RECORD OF DECISION

US 74 Shelby Bypass

**From 0.6 Mile West of SR 1162 to SR 1001
Cleveland County, North Carolina**

T.I.P. Project Number R-2707

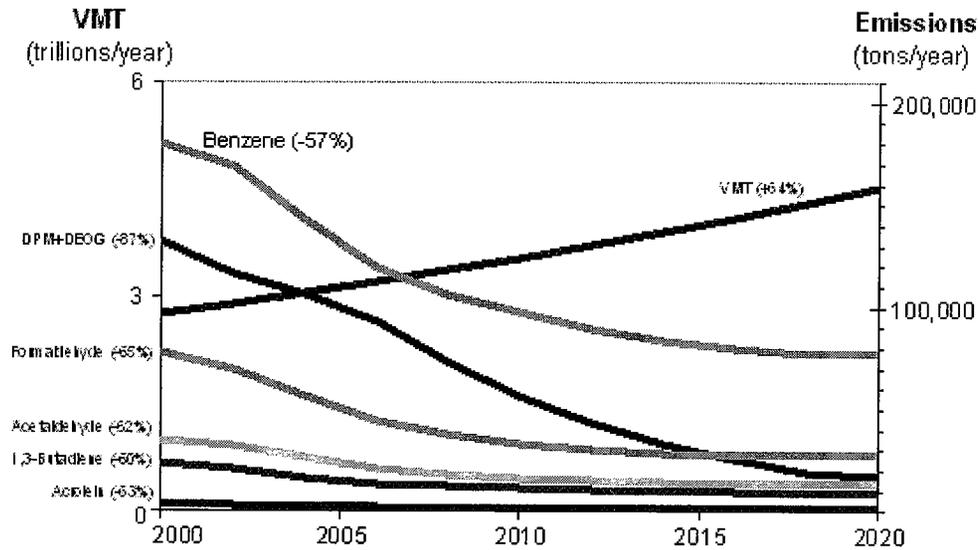
Comment: **6** - Project Description and Purpose and Need – “The document is unclear about the exact length of the proposed freeway. On Page 2-48, Table 2-10, the total length of the project based upon the project phasing for the 5 phases of R-2707 (A thru E) is estimated by EPA at 18.2 miles. Phases D and E are unfunded (i.e., Post year, after FY 2013). Phase C is only funded in the TIP for right-of-way acquisition in FY 2012. The Record of Decision (ROD) should clearly state the length of the new freeway.”

Response: **6** - The lengths of the various phases of the project are shown in the revised Table 2-10 in this ROD, page 43.
